Service Bulletin No.: DA20-24-03, Rev. 0

Title: Electrical Cables, Engine Compartment

2. Effectivity: DA20 Katanas S/N 10002 up to and including S/N 10300.

3. General: This service bulletin addresses the possibility of early fatigue of some ring terminals installed on heavy gauge wiring. Replacement of two electrical cables and relocation of two electrical cables located in the engine compartment is required.

Figure 1.

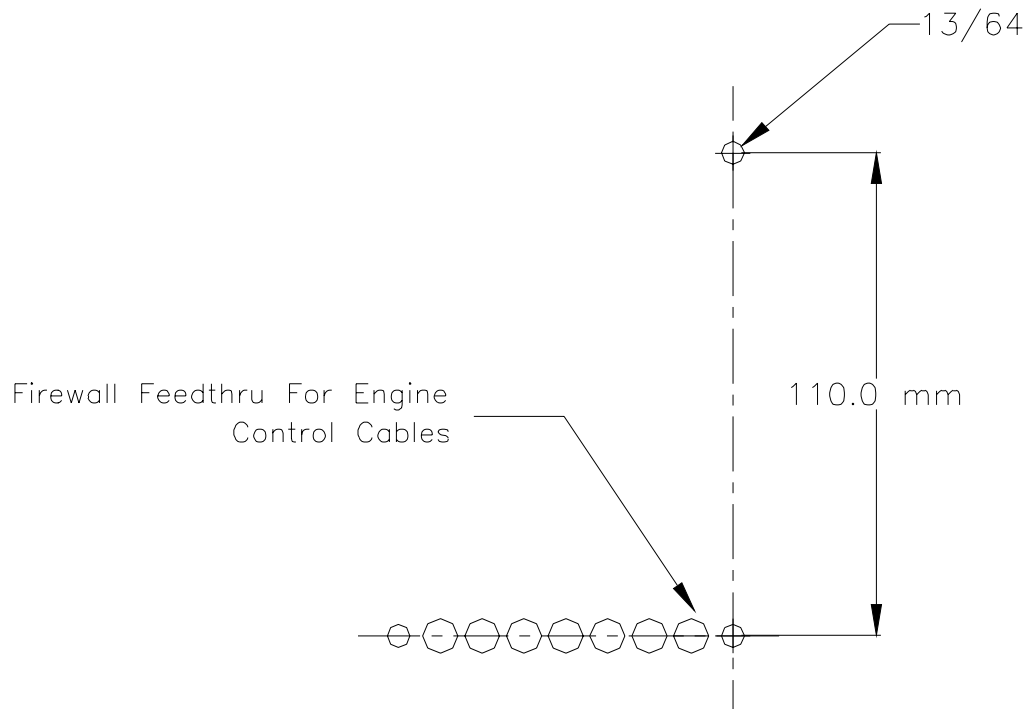
- 10.1 Remove the cowling.
- 10.2 Inspect the starter to see if the electrical stud for the power connection is pointing inboard or outboard. For aircraft with the electrical stud pointing inboard order material kit P/N DA20-24-03AMK0 (180mm starter cable). For aircraft with the electrical stud pointing outboard order material kit P/N DA20-24-03BMK0 (110mm starter cable).
- 10.3 Remove the old starter lead wire # 80103A4 and install the new wire cable assembly labelled #80103A4.
- 10.4 Disconnect the engine ground wire #24320A4N from the electrical shelf at one end and the #3 engine cylinder head at the other end. Remove the spiral wrap protective covering to allow removal of the wire from the harness.
- 10.5 Following the same routing install the new cable, wire #24320A4N. Reinstall the spiral wrap removed in 10.4.

Figure 2.

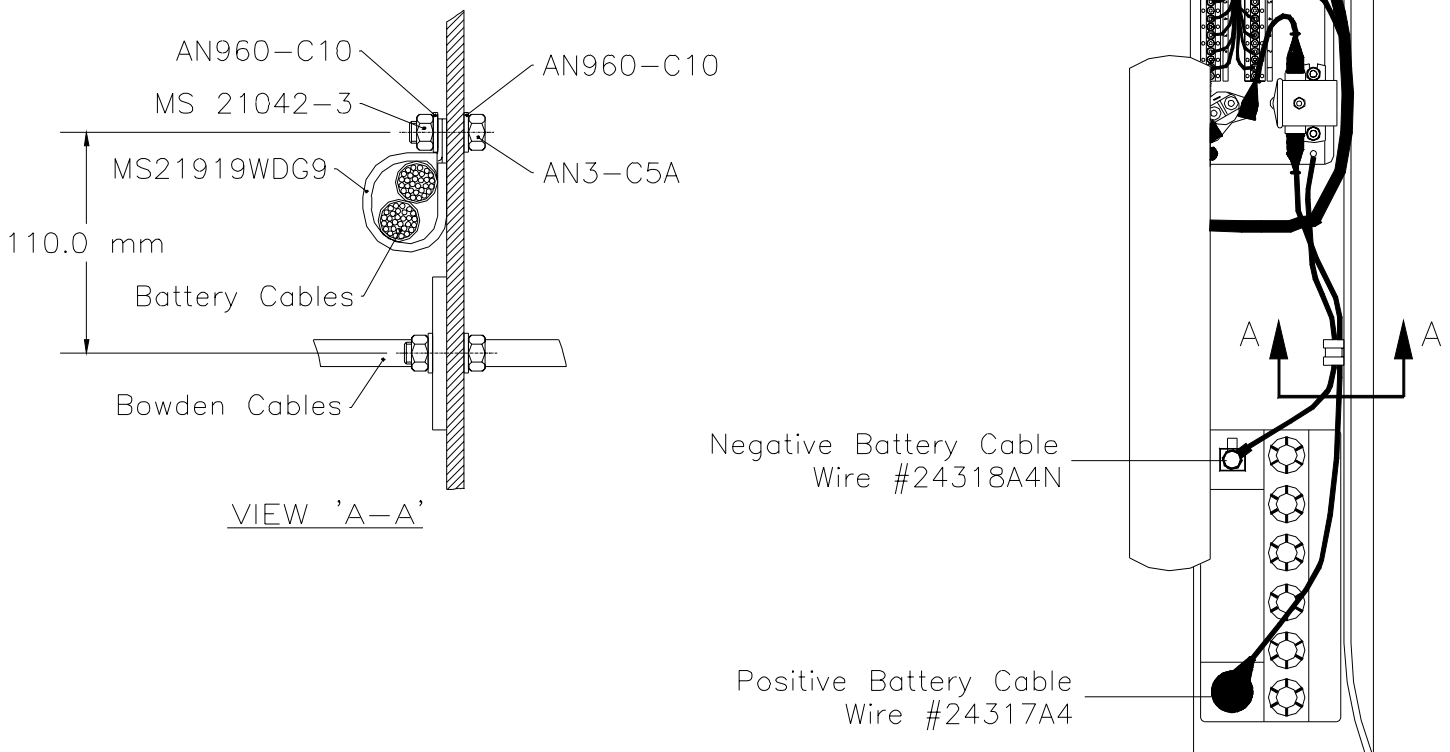
- 10.6 Disconnect the battery wires from the battery (negative lead first). Remove the battery from the battery box.
- 10.7 Remove the clamp holding the battery wires to the air box. Discard the clamp and mounting hardware.
- 10.8 Drill a 13/64 hole in the fire wall in the location shown in figure 1.
- 10.9 Put the wires into the clamp and install the clamp as shown in figure 2 for Rotax 912 F3 installations, or figure 3 for Rotax 912 A3 installations.
- 10.10 Reinstall the battery. Reconnect the battery cables making sure that the polarity of the connection is correct.
- 10.11 Check the operation of the battery, starter, and generator.
- 10.12 Reinstall the cowlings.
- 10.13 Make a log book entry in the aircraft technical log.

FIGURE 3

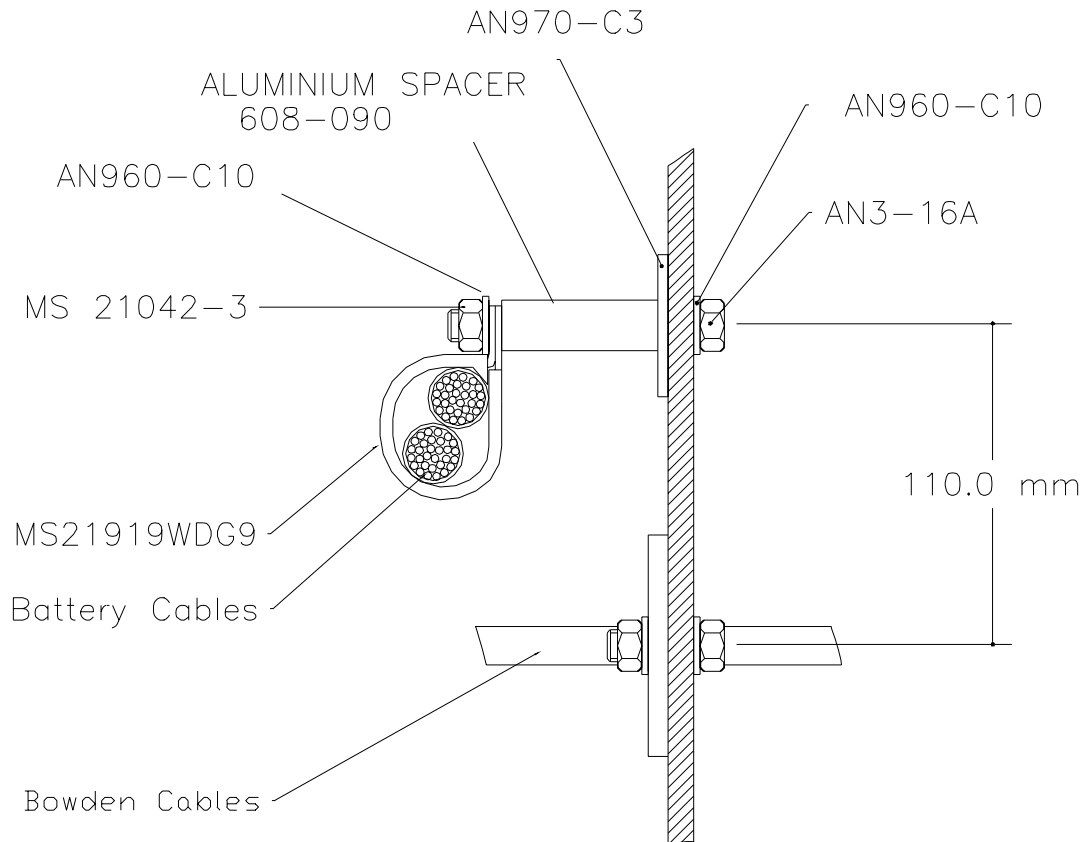
Use Spacer When Rotax 912 A3 Engine Installed
